Page Changes to MRP-169 Rev. 1 to Address the Presence of Alloy 600 Safe Ends

**Figure 7-1
Inspection Requirements for Weld Overlays**

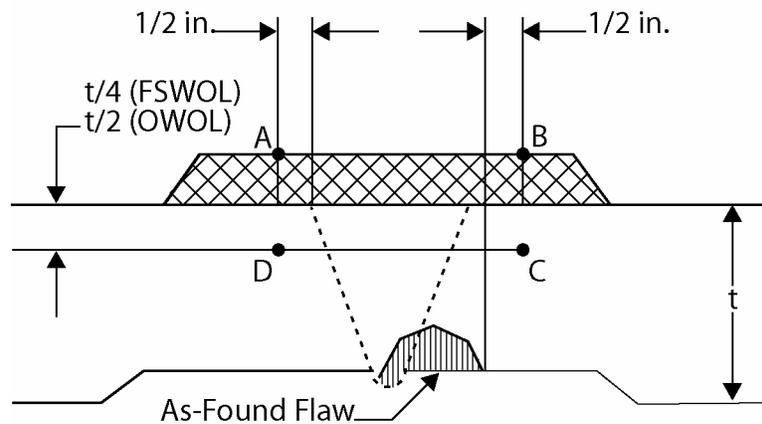
Note: Figure included clarifying that no modifications are necessary, since it already includes reference to PWSCC susceptible safe-end if present. However a typo was identified – the comma after nozzle should be deleted.

Volumetric: Overlay directly over original PWSCC susceptible weldment (including nozzle buttering, DMW and PWSCC susceptible safe-end if present) plus ½ inch to either side, to a depth of the outer 25% (FSWOL) or 50% (OWOL) of underlying material . (A-B-C-D)
